SERVICE BULLETIN

APPLICABILITY: 2020-23MY Outback & Legacy With 2.4L DIT
2019-23MY Ascent

NUMBER: 09-106-23

SUBJECT: Exhaust Pipe Front (EPF) Design Change

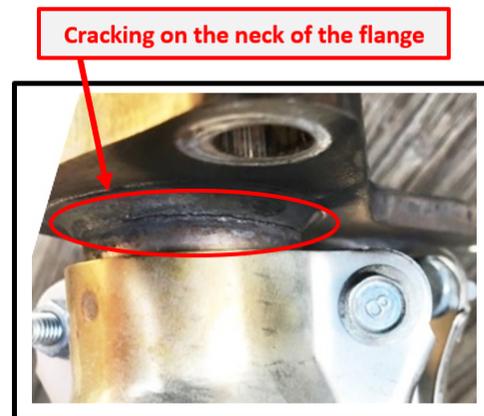
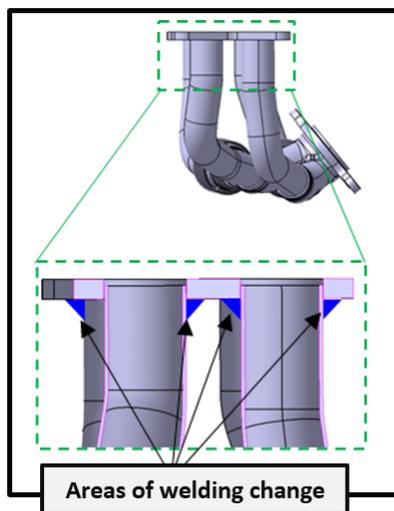
This bulletin announces design changes made to the Exhaust Pipe Front (EPF) to address concerns of rattle-type or fluttering sounds coming from the undercarriage during acceleration caused by cracking in the EPF. A welding material with enhanced durability has been incorporated into the production of the EPF. If the condition described is confirmed, the EPF should be inspected and if determined necessary, replaced.

The new EPF has been incorporated into vehicle production as per the table below.

Model	Starting VIN
Legacy	P3008074
Outback	P3154038
Ascent	P3409668
